**ALBERTA TRANSPORTATION SPRINGBANK OFF-STREAM RESERVOIR PROJECT
RESPONSE TO NRCB AND AEP SUPPLEMENTAL INFORMATION REQUEST 1, JULY 28, 2018**

Appendix IR14-5 Dam Alignment and Toe Location Relative to the Elbow River of the Springbank Off Stream Reservoir Project
May 2019

To:	Syed Abbas	From:	Hugo Aparicio, PE Scott Peyton, PE
	Alberta Transportation		Stantec
File:	110773396	Date:	July 22, 2016

Reference: Dam Alignment and Toe Location Relative to the Elbow River

DAM ALIGNMENT AND TOE LOCATION
 RELATIVE TO THE ELBOW RIVER
 ATTACHMENT 1
 STORAGE DAM LOCATION -
 CONCEPT COMPARISON

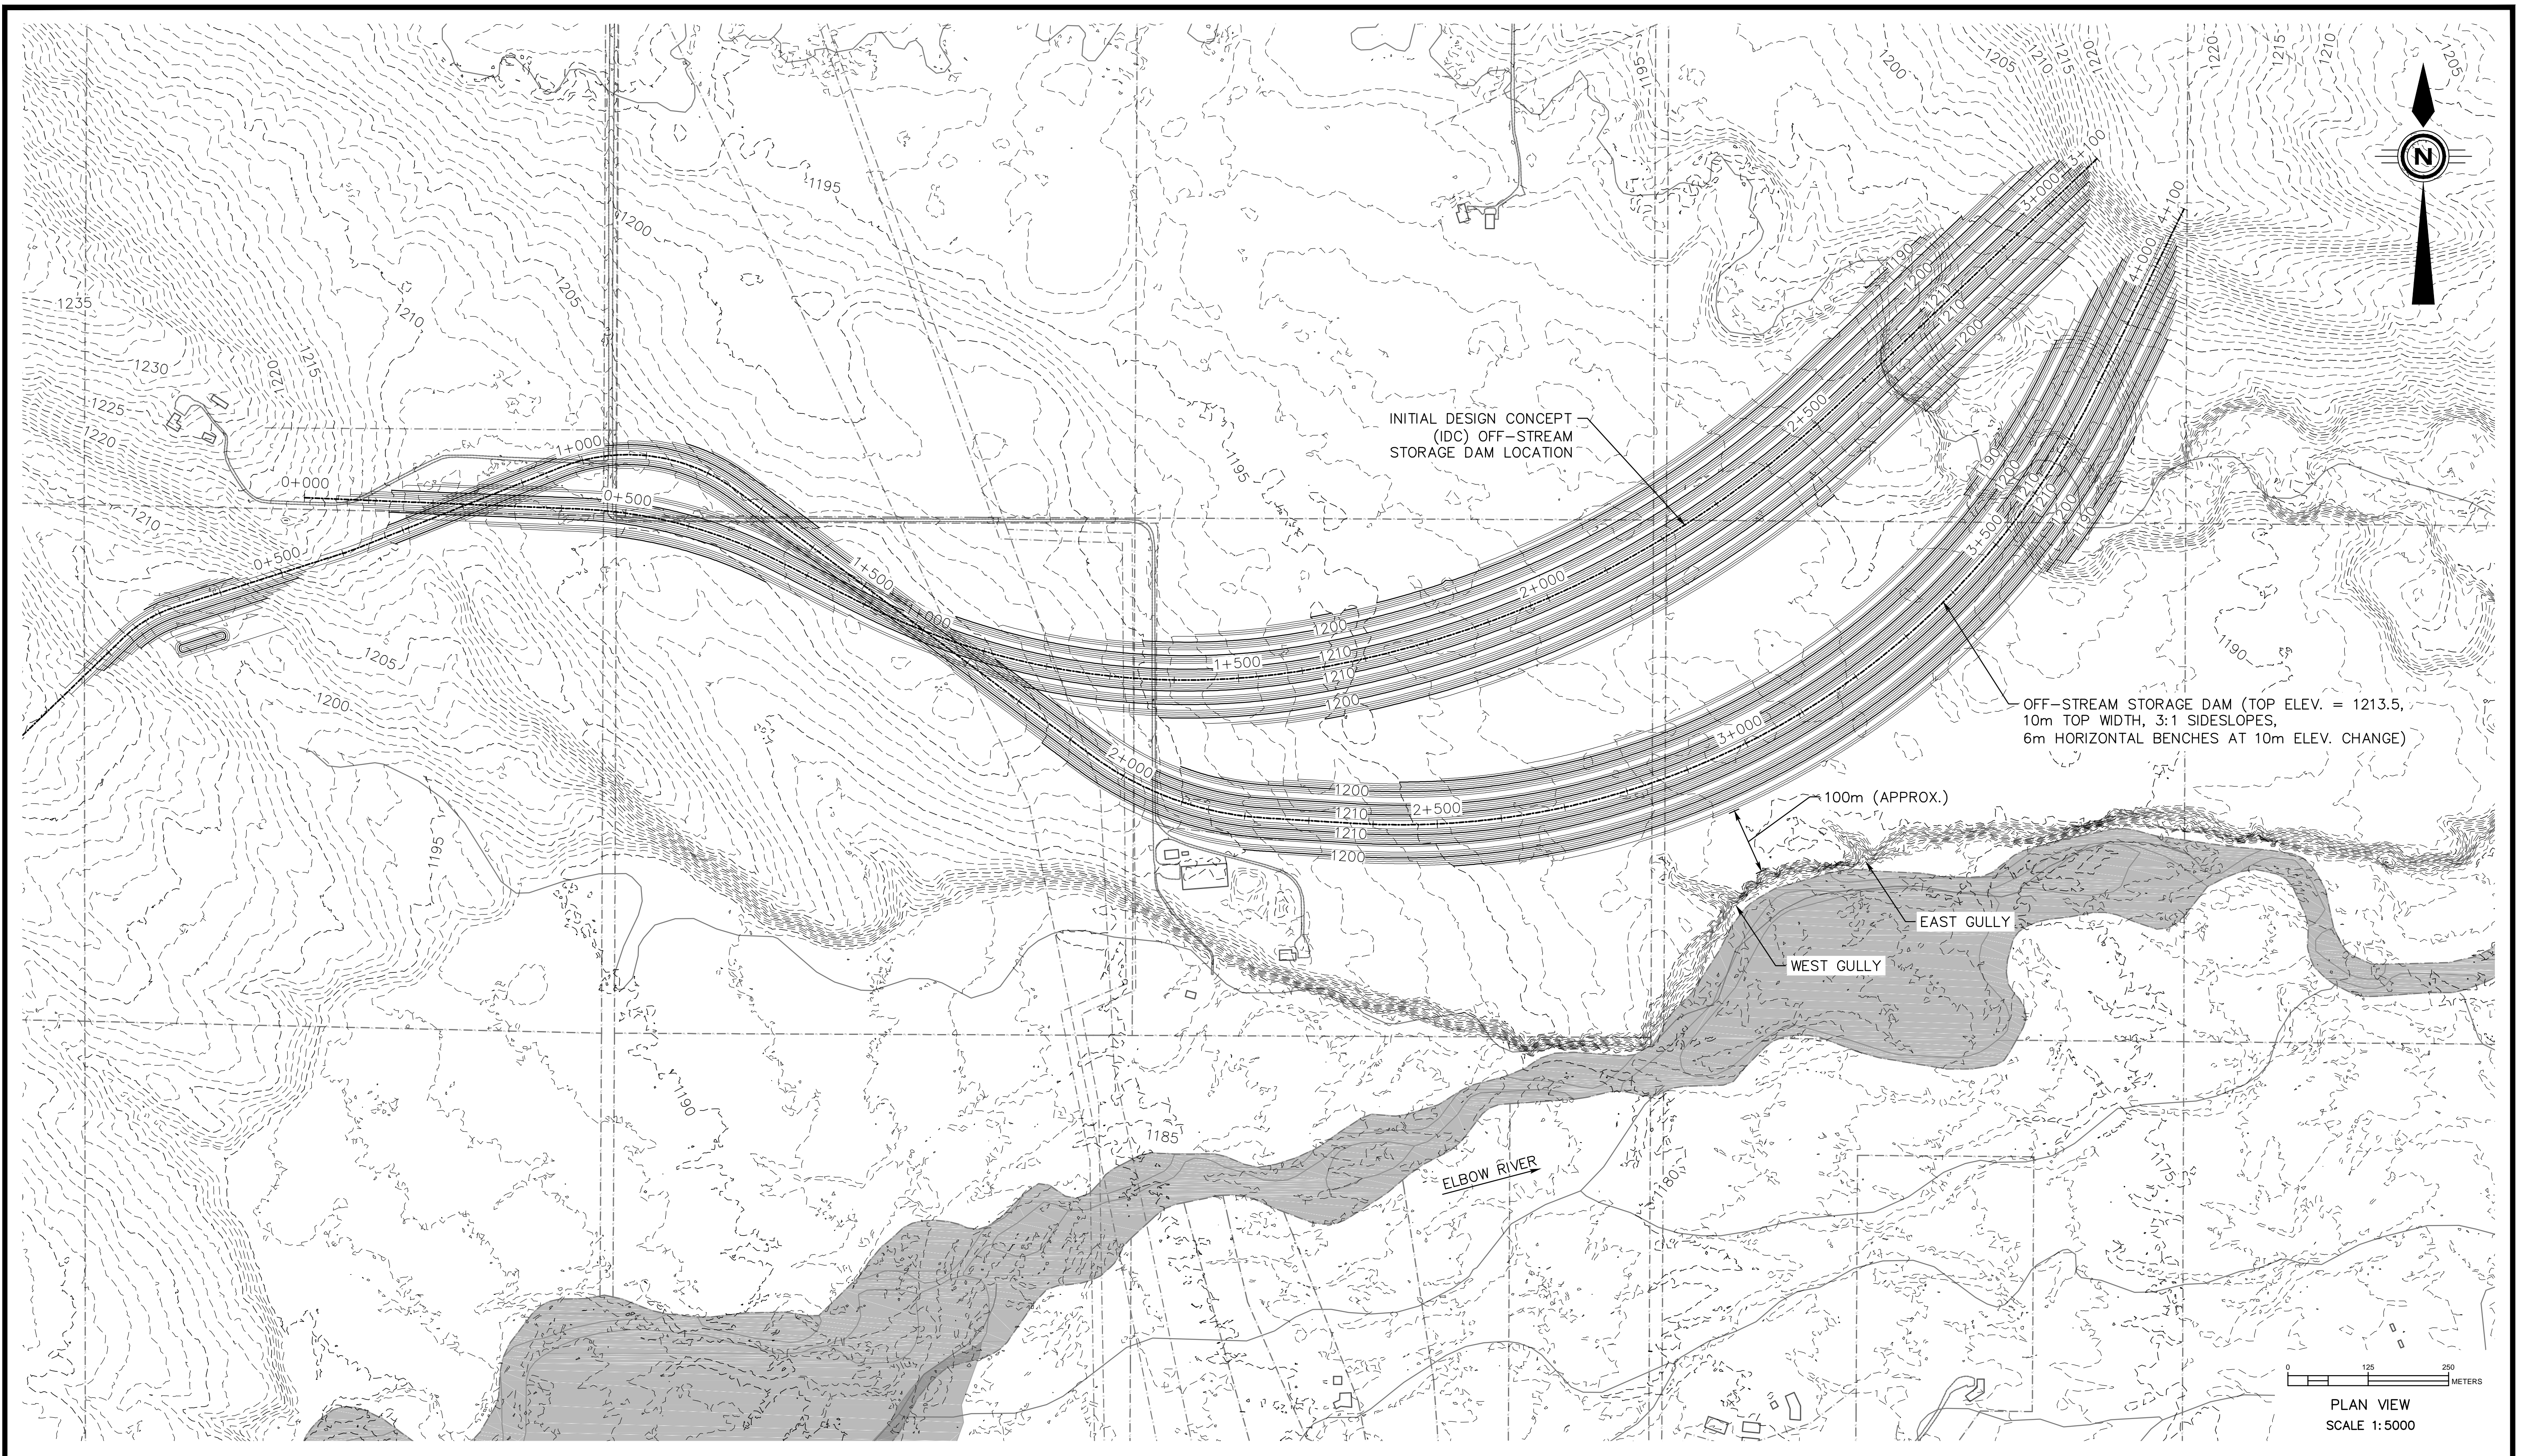
- 3. RB:** *The Board recommends that the benefits, design implications, and costs of moving the SR1 Dam further downstream, resulting in a possible lowering of the reservoir storage levels or, alternatively, providing additional storage, be further investigated, with due regard to the safety of the SR1 Dam toe under extreme flood conditions in the Elbow River.*

A comparison of the IDC (June 2014) and Stantec conceptual design (May 2015) storage dam alignment is shown in Attachment 1.

Stantec performed site reconnaissance along the toe of the Elbow River banks near the dam toe area on May 3, 2016. Two gullies were observed near the location where the dam toe is closest to the top of the Elbow River bank. The two gullies are shown in Attachment 1 in plan view. Photographs of the gullies are shown below in Figure 1; the photographs give good perspective on the size and scale of the gullies. The gullies were not reviewed in detail due to land access constraints.

Stantec recommends moving the Dam up-valley 100 metres from the preliminary design concept location presented in April 2015. The impacts of this change are negligible for cost (fill quantity and emergency spillway) and footprint area.

SPRINGBANK OFF-STREAM STORAGE PROJECT		
DAM ALIGNMENT AND TOE LOCATION RELATIVE TO THE ELBOW RIVER ATTACHMENT 4 STORAGE DAM REALIGNMENT CONCEPT OPTION 3		
SITE	SHEET	CONSULTANT DRAWING
SR1 - ROCKY VIEW, ALBERTA	7 OF 7	TRANSPORTATION DRAWING

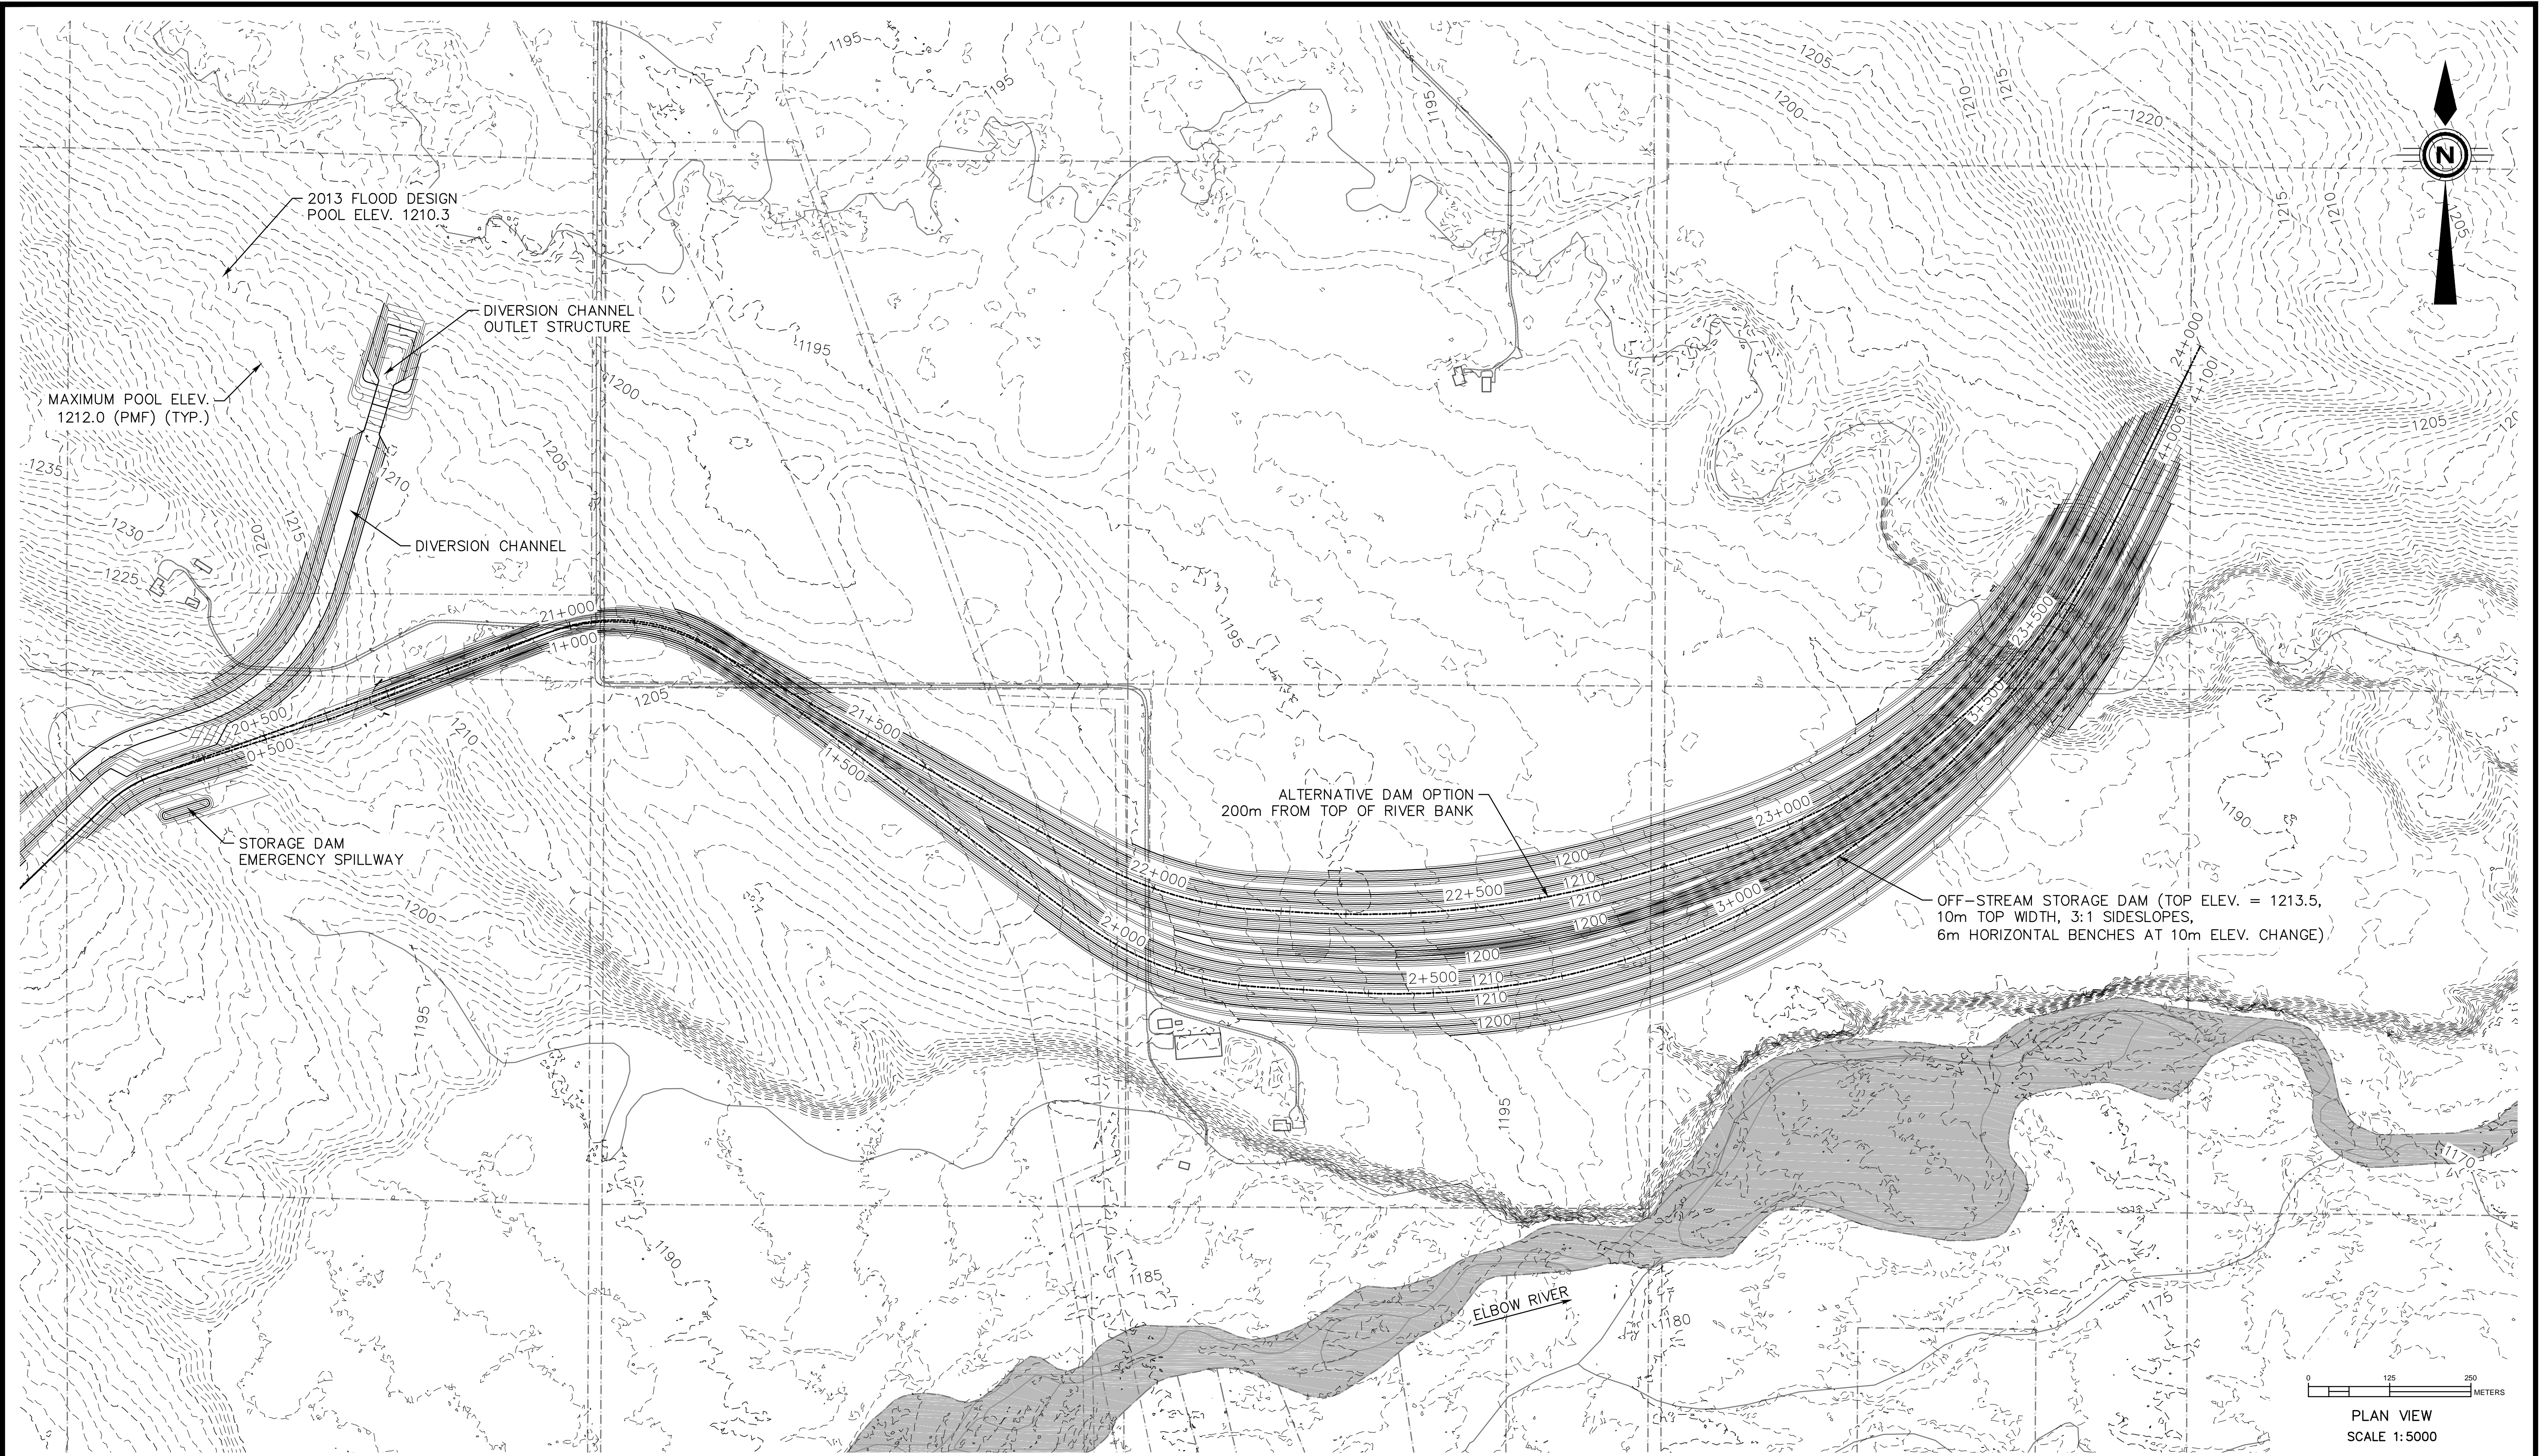
The third alternative for addressing bank erosion risks is to relocate the dam approximately 100m upstream from the current concept, locating it approximately 200 m from the top of bank of the Elbow River at its closest location. Relocation of the storage dam further upstream would have a relatively small impact on reservoir storage. SR1 storage needs of the 2013 storm event produces a level flood pool elevation of 1210.3 m for the current concept. Moving the dam upstream would raise the pool elevation to 1210.6 m given the same storage needs.

Attachment 4 shows this alternative dam alignment. Conceptual versus alternative storage dam quantity impacts are shown in Table 5.
